UNITED STATES PATENT AND TRADEMARK OFFICE

APPLICATION NO.	FILING DATE	FIRST NAMED INVENTOR	ATTORNEY DOCKET NO.	CONFIRMATION NO.
10/691,380	10/22/2003	Masaaki Tabata	FP03-051US	8661
1218	7590	05/28/2004	EXAMINER TA, THO DAC	
CASELLA & HESPOS 274 MADISON AVENUE NEW YORK, NY 10016			ART UNIT 2833	PAPER NUMBER

Office Action Summary	Application No.	Applicant(s)	
	10/691,380	TABATA ET AL.	
	Examiner	Art Unit	
	Tho D. Ta	2833

DETAILED ACTION

FIG. 1

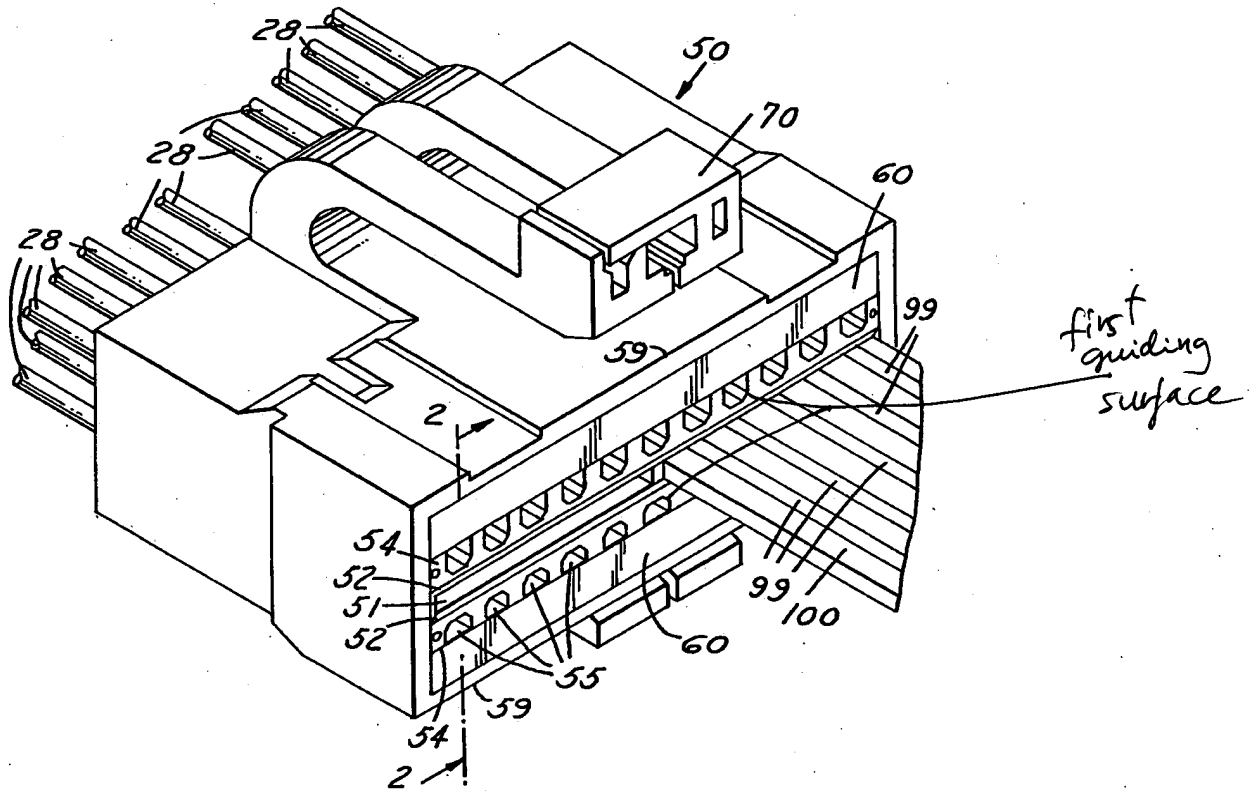
In regard to claim 1, Cairus et al. discloses a connector with a housing (50) having at least one cavity (55), a resiliently deformable lock (56) provided at a first surface of the cavity (55) and being resiliently deformable into a deformation permitting space (58), at least one terminal fitting (10) with a tube insertable into the cavity (55) along an insertion direction, the terminal fitting (10) being configured to deflect the lock (56) into the deformation permitting space (58) during insertion and to be engaged by the lock (56) after complete insertion of the terminal fitting (10) in the cavity (55), and a retainer (60) mountable to the housing (50) and insertable into a deformation permitting space (58) for preventing resilient deformation of the lock (56), wherein: an area of the cavity (55) for accommodating the tube has a cross section substantially conforming with the tube, a first guiding surface (see fig. 1) at least at one corner of a second

surface of the cavity (55) substantially opposite to the first surface of the cavity (12) for narrowing the cavity (55) in directions transverse to the insertion direction, the tube of the terminal fitting (10) being pressable against the first guiding surface by displacing the lock (56) towards the terminal fitting (10) when the retainer (60) is mounted, thereby preventing the terminal fitting (10) from shaking in lateral and/or vertical directions.

In regard to claim 10, Cairus et al. discloses that the at least one chamfered longitudinal corner comprises two opposed chamfered longitudinal corners (see fig. 1).

Chamfered transverse corner
or
second guiding surface

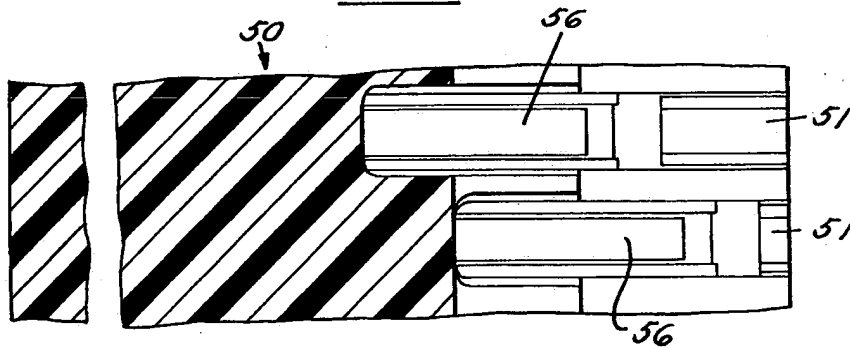
In regard to claim 6, Cairus et al. discloses that a second guiding surface (see attached drawing) for shortening the cavity (12) in directions parallel to the insertion direction at locations adjacent the second surface of the cavity (55).

In regard to claim 8, Cairus et al. discloses that the first guiding surface (see fig. 1) and the second guiding surface (see attached drawing) are provided on facing corners of the second surface.

In regard to claim 11, Cairus et al. discloses that the second surface further has at least one chamfered transverse corner (see attached drawing) extending along the width direction of the cavity for shortening the cavity at locations adjacent the second surface and in the longitudinal direction.

FIG. 2FIG. 3

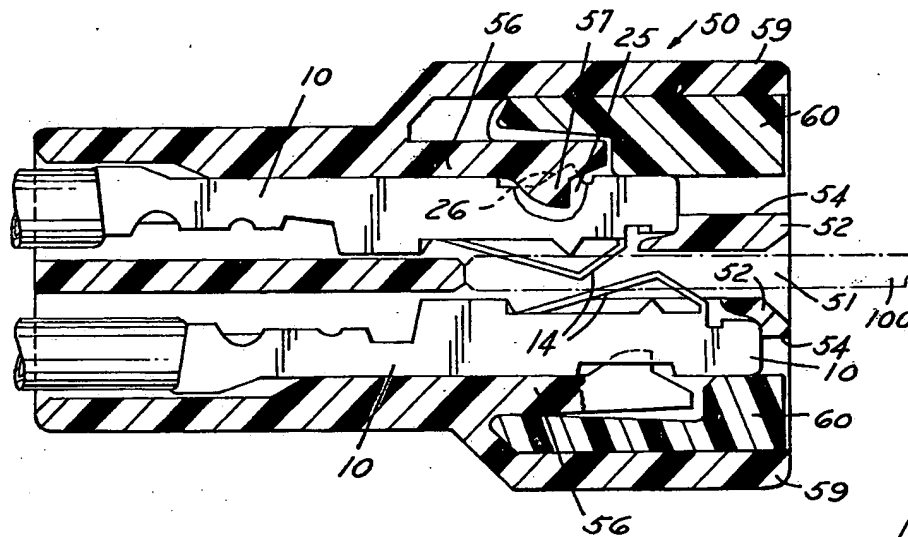
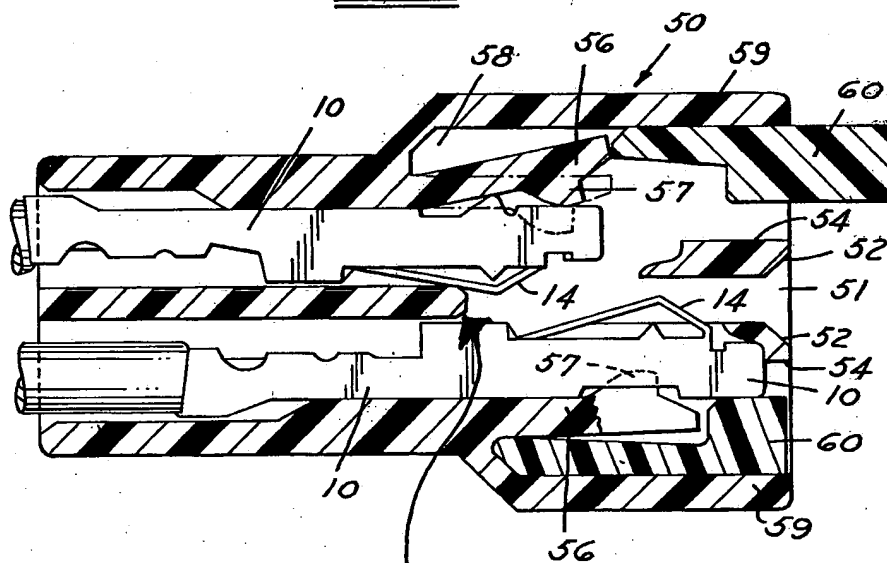
In regard to claim 2, Cairus et al. discloses that a guiding section (the surface where retainer 60 engages as shown in Figures 2 and 3) is formed on the lock (56) for forcibly displacing the lock (56) towards the terminal fitting (10) upon the insertion of the retainer (60).
